McARTHUR RIVER MINE OVERBURDEN MANAGEMENT PROJECT

Northern Territory Environment Protection Authority
Northern Territory Department of Primary Industry and Resources

Overburden Management Project Supplementary EIS Review

May 2018
Report No. 01164E_2_v3

Figure 3.2 – Simulated Long-Term Loadings to the Barney Creek Diversion

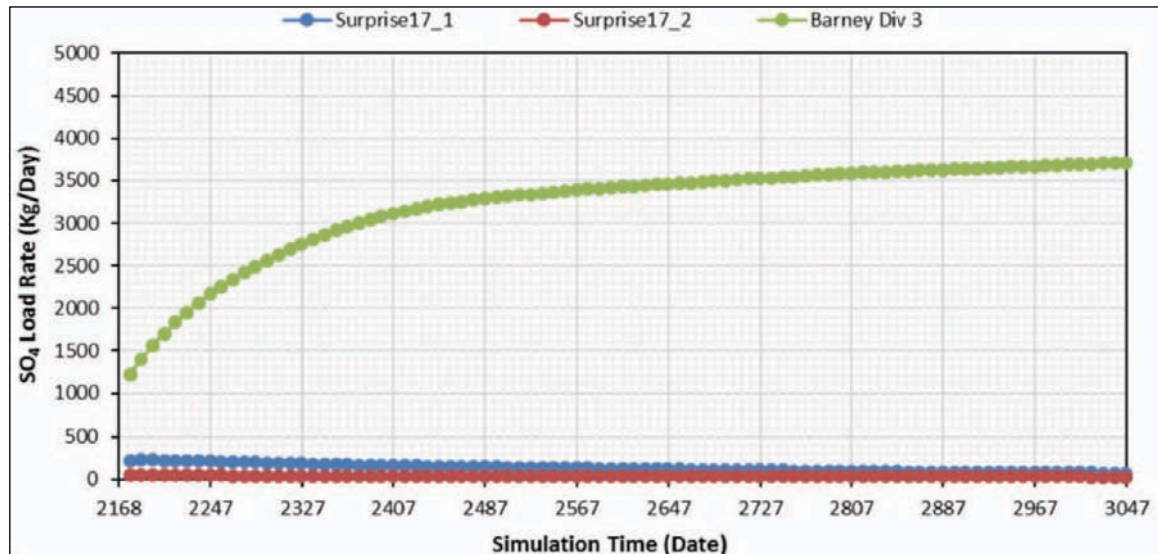
- ♦ Long-term groundwater contamination between the NOEF and the Barney Creek diversion, which is going to be used as an interception drain to capture seepage from the dump. Figure 3.2 shows predicted loadings to the diversion, which continue to rise over the 1,000-year simulation period reaching 3,700 kg/day in 3047.

Figure 3.15 – Simulated Upper Bedrock Sulphate Concentrations after Closure

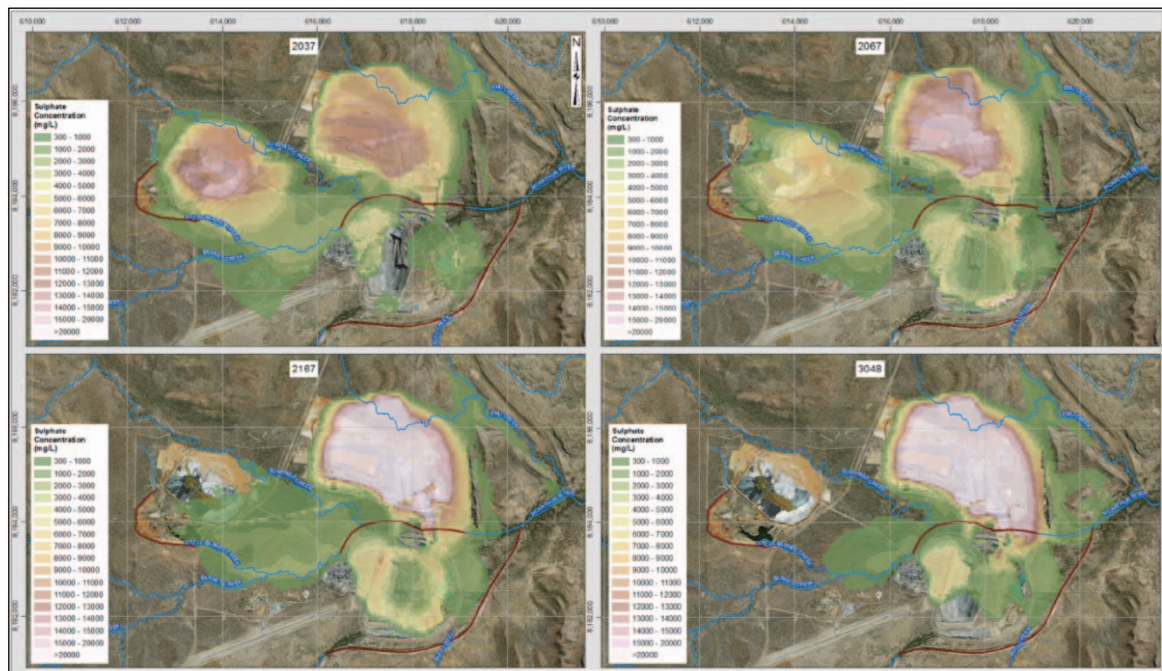
The groundwater modelling results indicate seepage migrating southeast from the TSF area and underneath Barney Creek during operations and immediately after closure (i.e., before the pit is flooded) will be captured by the drawdown cone around the pit. There is a risk that some seepage from the TSF may report to the McArthur River upstream of the pit. However, the impact from this discharge is likely to be low, given the low baseflow to the upstream McArthur River reaches. Further more, long-term modelled sulphate concentrations (Figure 3.15) show dilution of the plume as it migrates southeast in response to rainfall recharge, which will limit impacts on the baseflow to the McArthur River upstream of the diversion.

The predicted sulphate loadings after mine closure are shown spatially in Figure 3.15, which shows the sulphate plume migrating away from the TSF footprint with near background concentrations in the Surprise Creek area by 2167.

Figure 3.16 – Simulated Surprise Creek LoM Sulphate Loading

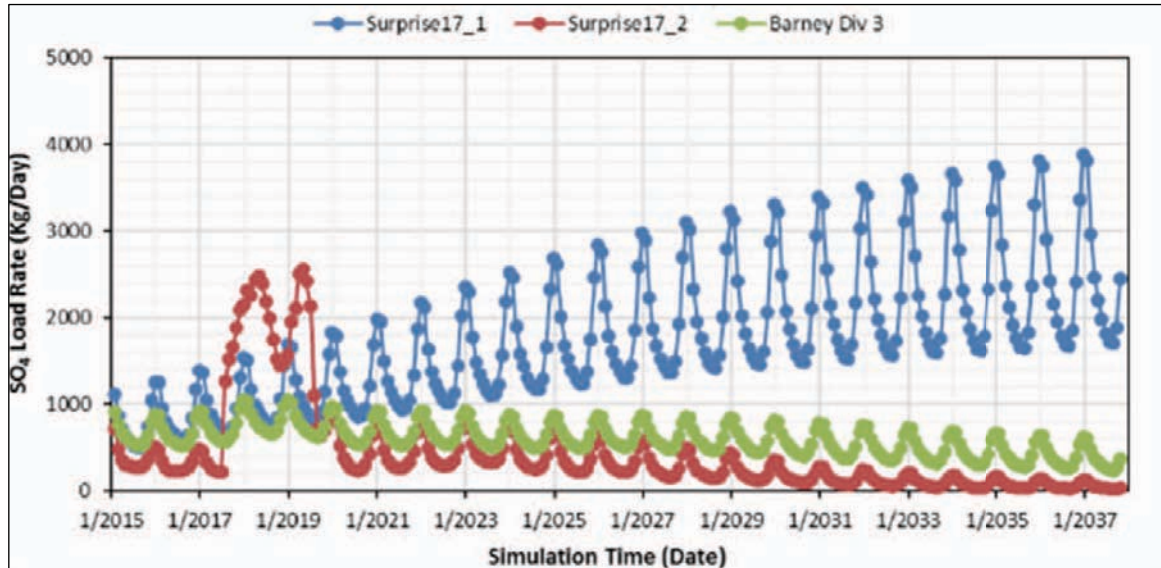
- ♦ Sulphate loadings rise over the life of mine from between 500 and 1,000 kg/d to between 1,700 and 3,900 kg/d in 2038.
- ♦ The rising trend in sulphate loadings continues up until 2044, while tailings are being relocated into the pit void.
- ♦ After 2044, loadings reduce reaching background concentrations after 2087 as the plume migrates to Surprise Creek.

Figure 4.5 – Water Volumes Stored in Open Cut and Underground

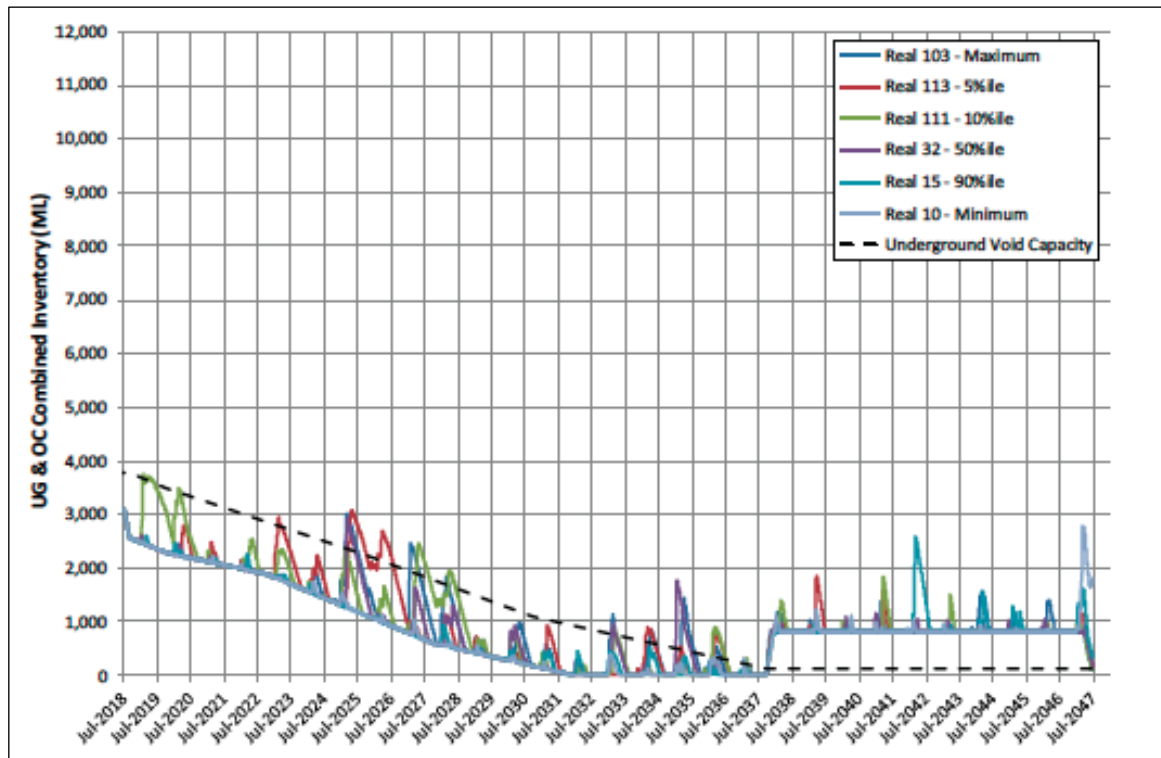
Figure 4.5 shows underground void capacity, being about 3,800 ML in 2018 and decreasing in a linear manner to about 100 ML in 2037, when in-pit tailing deposition commences. Figure 4.7 shows excess water required to be stored in the open cut due to the capacity of the underground void being exceeded (under various climatic scenarios).

Figure 4.6 – Modelled Stored Loads of Sulphate

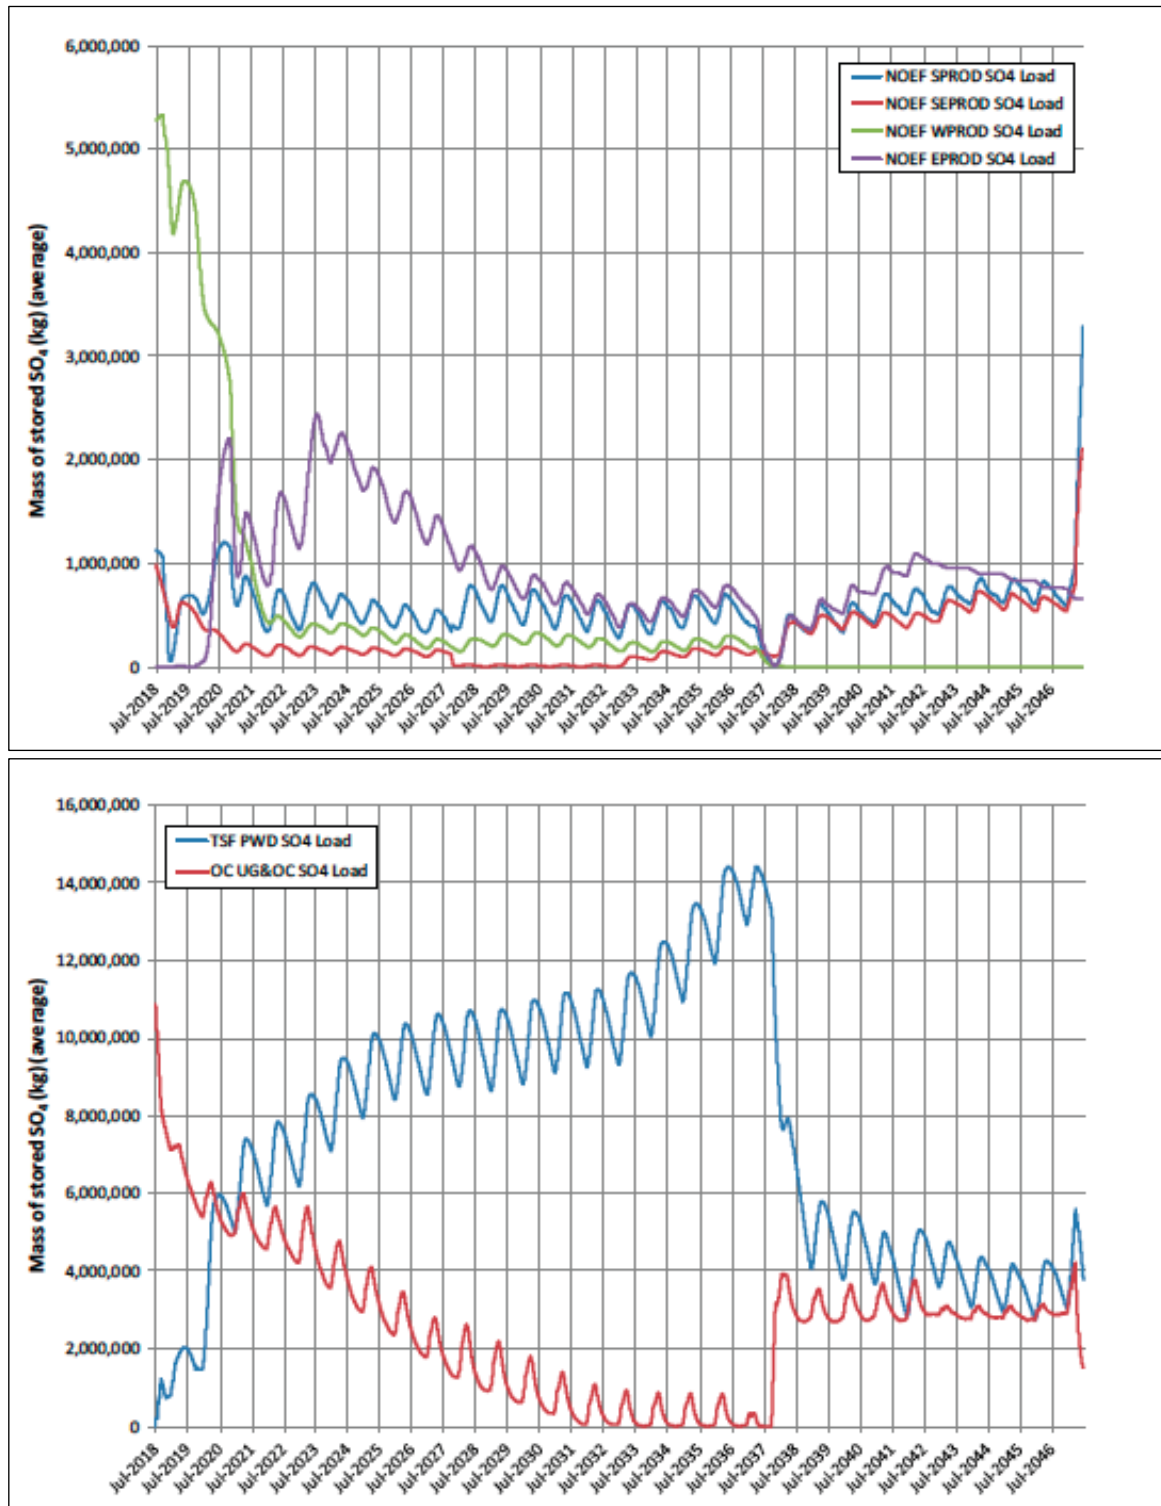
Modelled stored amounts of sulphate in the NOEF PRODs, TSF PWD and the open cut are described in Appendix N (WRM, 2018), Section 3.4.1, and shown in Figure 4.6 above from 2018 to 2047. At the start of the simulation most sulphate is stored within the open cut and NOEF WPROD (which collects the highest amount of NOEF toe storage and water from the open cut). Following completion of construction of the TSF PWD in 2019, most of the sulphate is stored within this dam. The amount of sulphate in the TSF PWD increases until the commencement of in-pit tailing deposition in 2038, due to the decreasing storage capacity of the open cut underground void as mining progresses. From 2038 the amount of sulphate in the TSF PWD reduces as this water is used in the processing of tailings and transferred to the open cut. The Mill Water Treatment Plant (WTP) also treats water during this period and removes sulphate from the site water management system.

Figure 4.10 – Comparison of Background and McArthur River SW11 Sulphate Loads for Closure Period

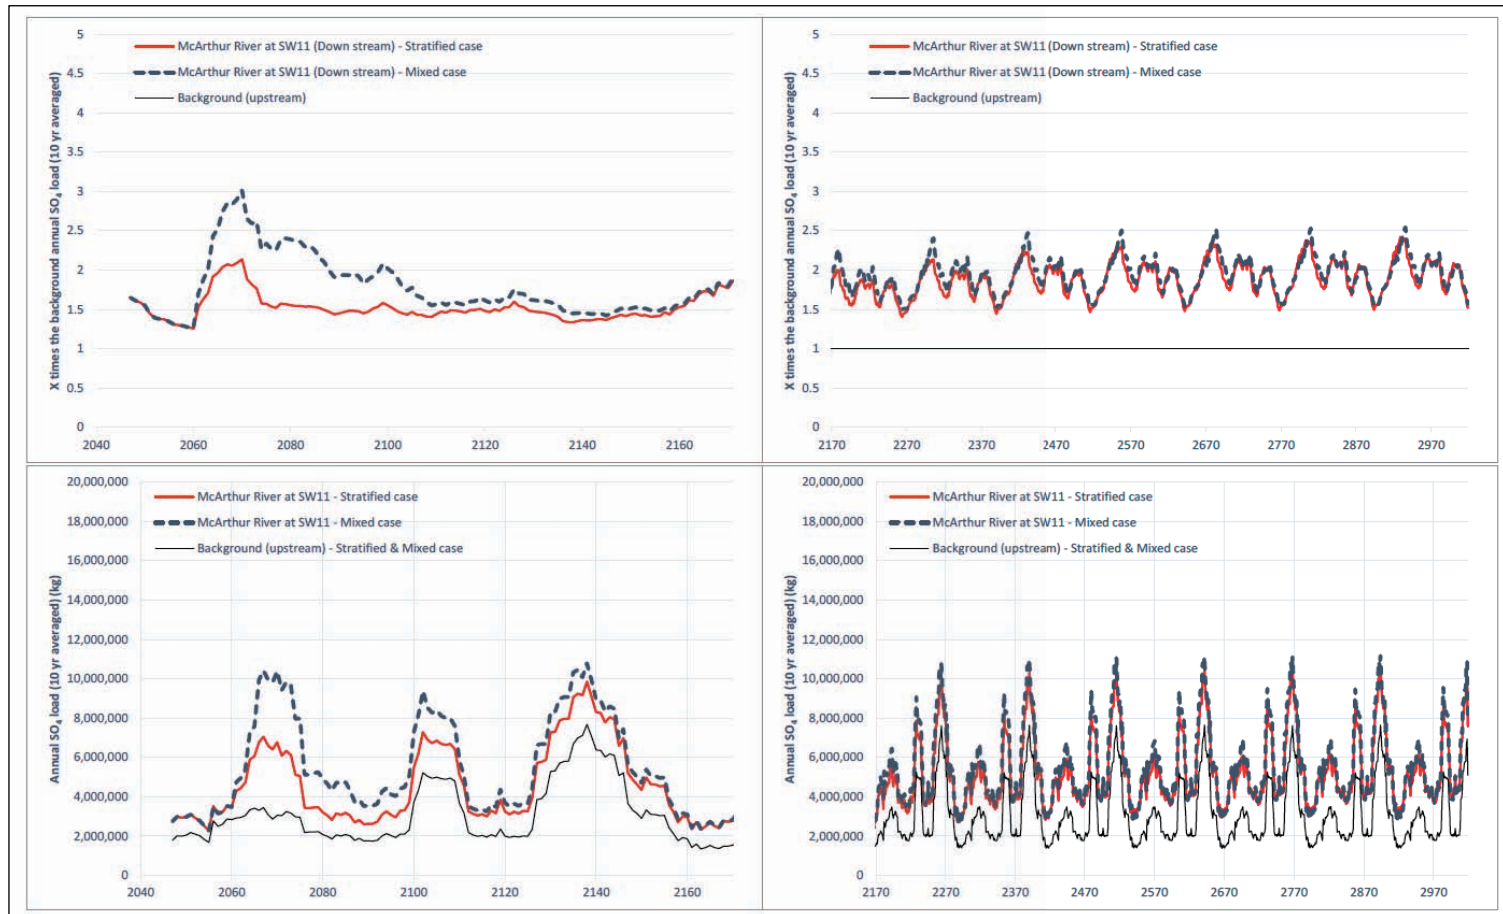
The predicted annual sulphate load at SW11 in the McArthur River is initially approximately 1.3 to 1.4 times the load from background (upstream) sources between 2047 and 2060 (Figure 4.10). The calculated sulphate loads increase to about 2.2 times and 3.0 times above the background load from 2060 to 2070 mainly due to the initial interaction of the Mine Pit Lake with the receiving environment (for both the stratified and mixed lake cases). From 2080, the calculated annual sulphate load at SW11 is approximately 1.5 to 2.5 times higher than the background load (see Figure 4.10). Most of the annual sulphate load at SW11 occurs mainly during the wet season during outflows from the Mine Pit Lake. During dry periods, very little load passes SW11 due to very low background flow in the river and the collection of affected groundwater in the Barney Creek sumps.
